GRANT BLVD HIST. DIST

Conservation District Review

Property 2759 N. 6TH ST.
Description of work Replace front porch deck and railings.
Date issued 6/5/2007 PTS ID 42821 Conservation district review

Basic Railing and Newel Post Design

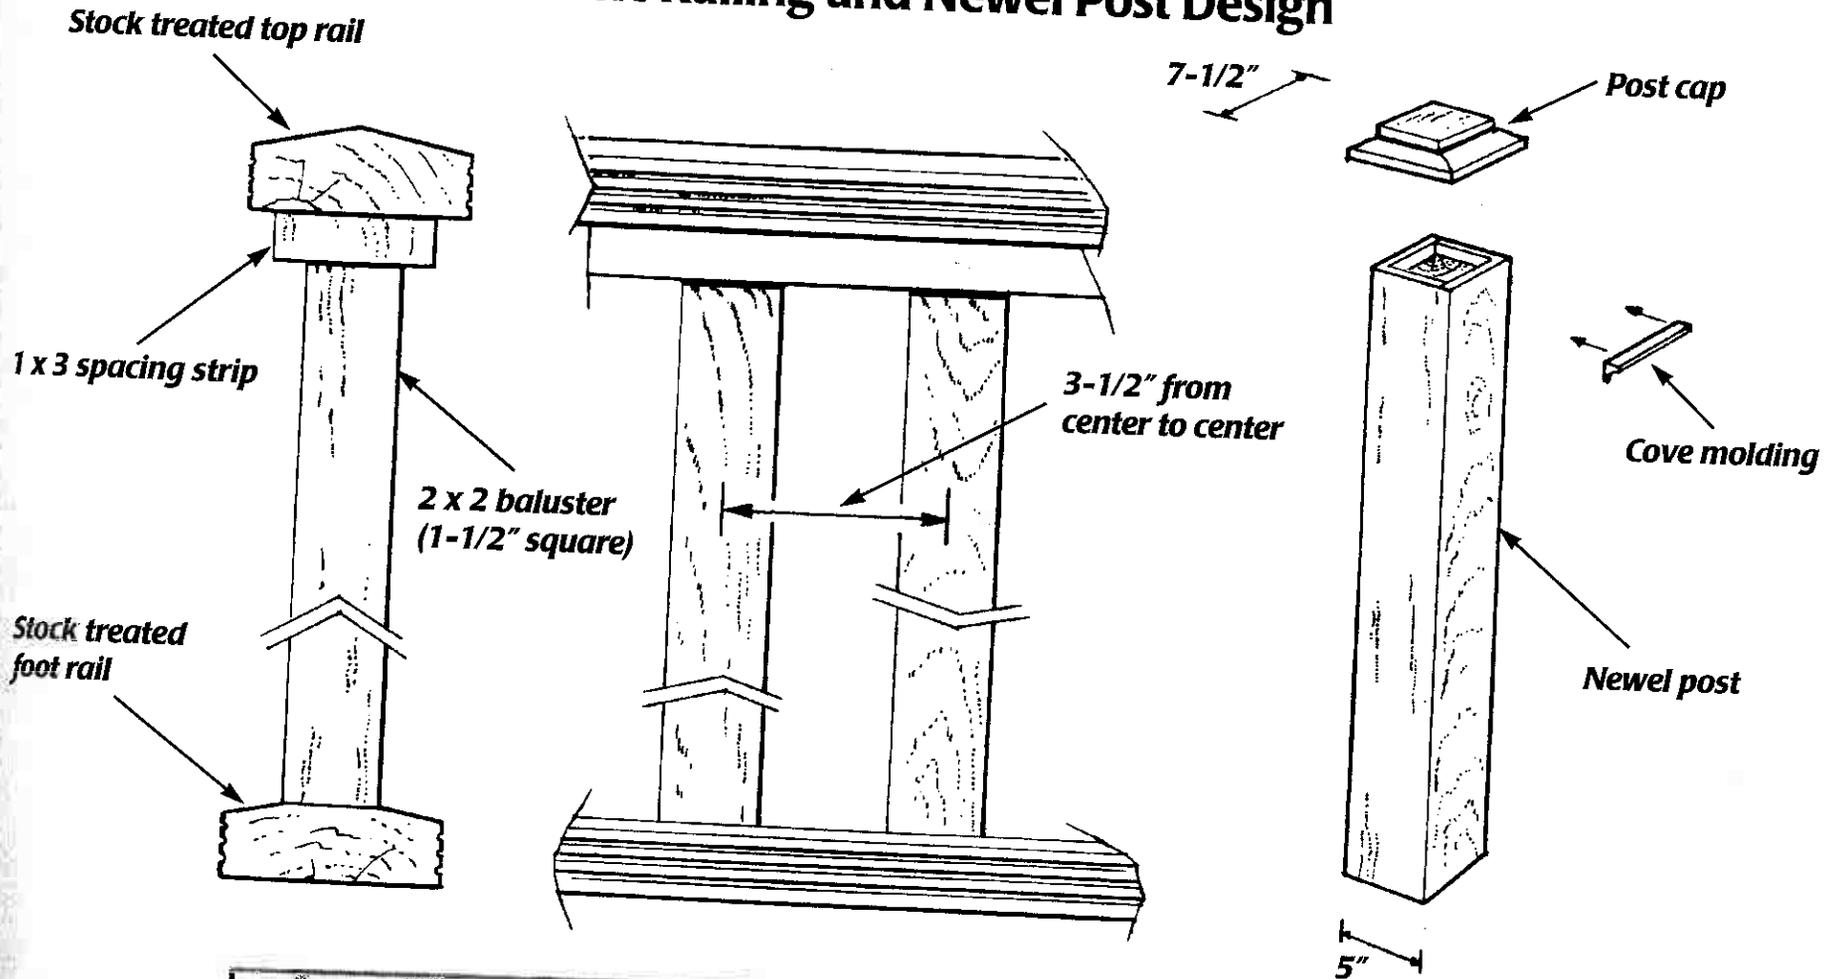
Porch should be reconstructed in exact same footprint as the original. Handrail/guard rails should be built according to attached drawings. All finish wood must be painted upon completion. Please note that research has shown that when new, bare wood is exposed to the elements for period of only a week, the life of the paint job subsequently applied to it will be decreased.

The number of historic handrail and newel post designs is literally endless. The above designs are appropriate for many houses built before 1940 and would be approved by the Historic Preservation Commission for most homes.
